**Real Estate Task Force Testing Workshop Report,  
November 30, 2004 to December 4, 2004  
Dick Farley, Civitas Inc.  
December 9, 2004 Revised December 16, 2004**

**Lakeridge: multi-family townhouse infill**

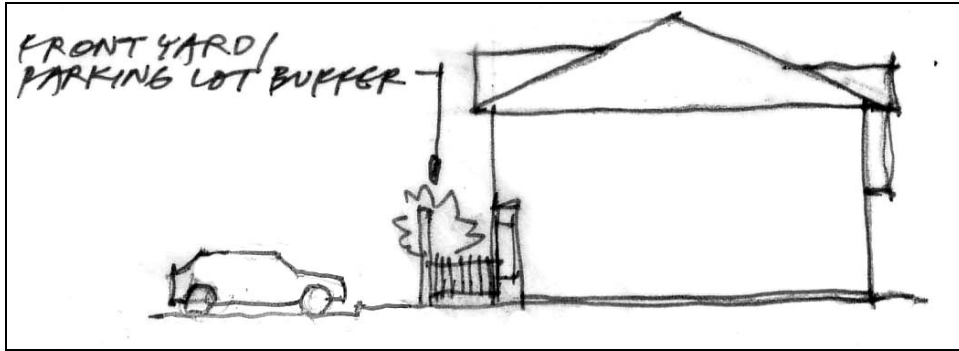
1. Tree retention reduces number of possible buildings.
2. Early tree removal affects geo-technical access.
3. Private common open space reduces number of possible buildings.
4. Uniform, unvaried buildings.
5. Lack of buffer between the front door and the parking lot..
6. Unclear whether Parking lot landscape standards and interior site landscape standards are both required, or whether one can substitute for the other.
7. Snow storage.
8. Lack of purpose for private common open space.

1. Reduce tree canopy requirement or focus on specimen trees. Allow private yards to count for some private common open space requirement.
2. Allow credit for nearby off-site preserved tree canopy.
3. Modify early tree removal requirement so that geo-technical access can be done.
4. Clarify purpose of private common open space requirement, particularly for children.
5. Require some spatial and landscape buffer between a unit's front door and a parking lot/drive, where parking is in a lot (no garage).(Figure 1)

##### Seclusion Bay: Suburban small lot single family infill

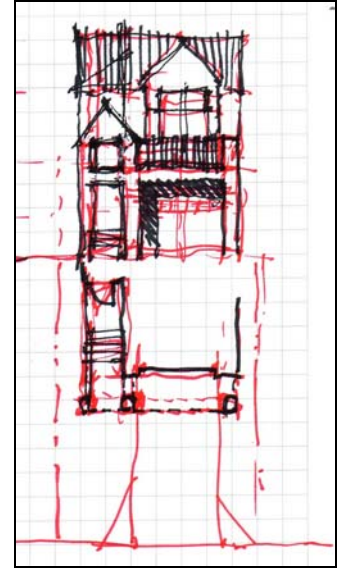
1. Garage door proportion of front façade. May eliminate this small lot single family building type which has a popular market.
2. How to provide incentives for small lot single family housing that is not garage dominated, or where the garage is recessive.
3. Front yard landscaping.
4. Architectural variety.
5. Purpose of private common open space.

1. Mitigate impact of garage door by recessing it behind a porch-like extension in front of it, possibly with a balcony over the garage door and extend the front door access into this porch-like zone. (Figure 4)
2. Create a garage door menu/front door menu with at least one choice from a short list of desired elements:
3. Provide incentive for alleys (so that garage doors are at the back of the house rather than the front) by: (Figure 5)
  - Allowing narrower streets.
  - Reducing front yard setbacks.
  - Not requiring or reducing private common open space.
  - Not requiring snow storage.
  - Allowing attached sidewalks or walking in the streets.
  - Green courts without street in front, only alleys behind.
  - Not requiring tree canopy preservation.

**Golden View: Suburban medium / large lot single family**

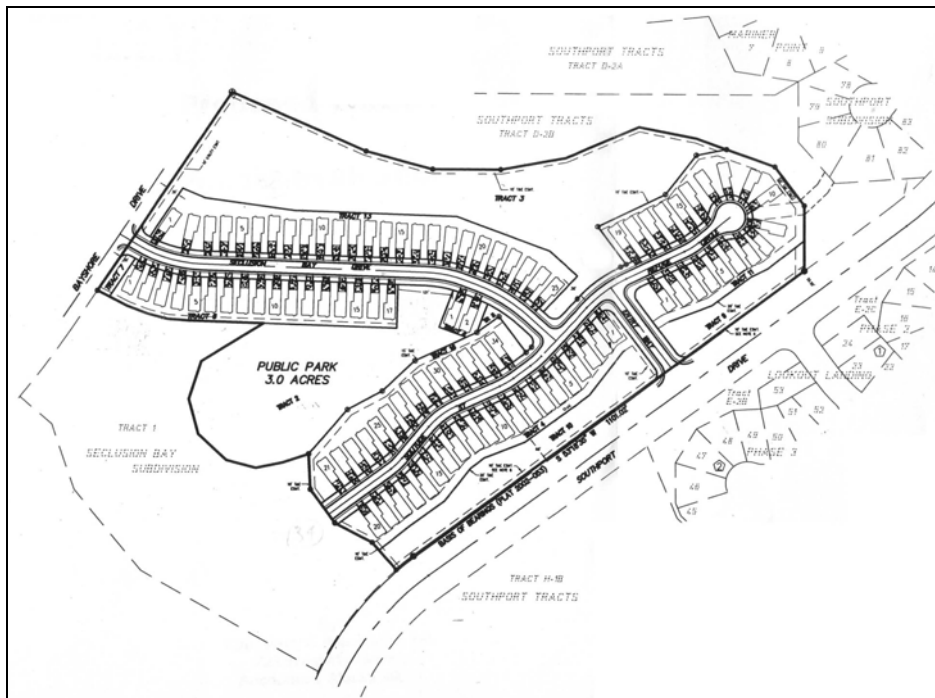
1. Private open space requirements plus public open space requirements reduce lots significantly.
2. Slope requirements mostly impact through retaining wall height limits.
3. Garage door proportion to the length of the front façade.
4. Tree canopy requirements.

1. Increase height of retaining walls with possible new material requirements.
2. Allow stepped retaining walls.
3. Develop a more-inclusive garage / garage door menu, such as:
  - Third car garage door stepped back from first / second car door;
  - Garage doors under a balcony the full length of the door;
  - Recessed doors
  - Painted doors;

(Figure 6b) – Example of green courts at Seclusion Bay.

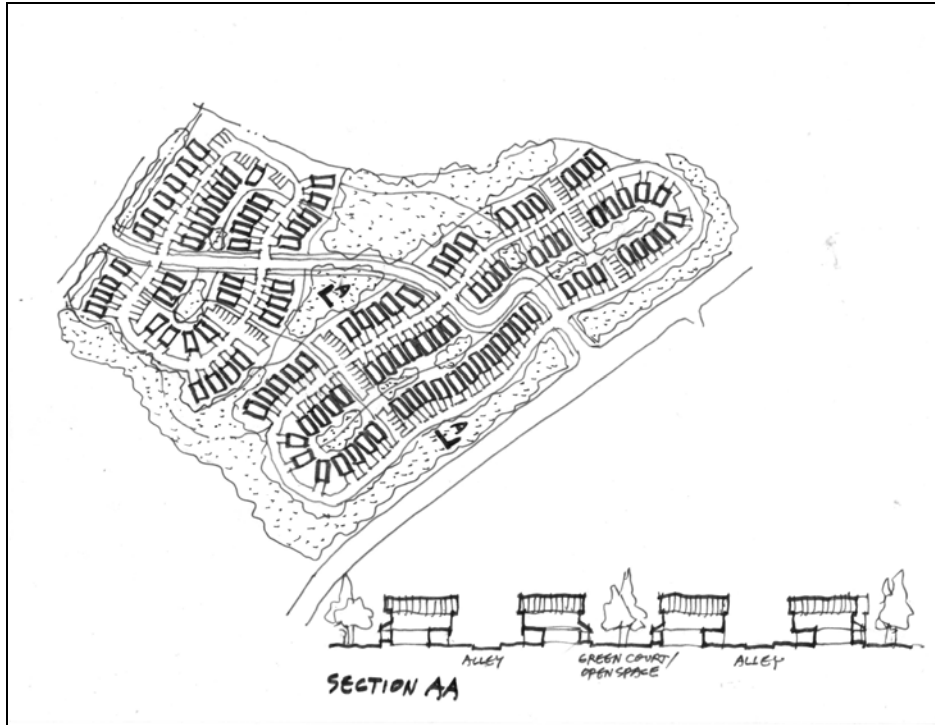
- Material or color variation
  - Windows in doors;
  - Special paving patterns in driveways
  - Enhanced landscaping
  - Curb cut narrower than combined driveways
  - Streetscape
4. Possibly relate garage door proportion to the entire area of the front façade, as well as to the length of the façade.
  5. Provide incentives for single loaded streets/lots on a slope or discourage lots that cut deeply back into the slope. (Figure 6a & b)
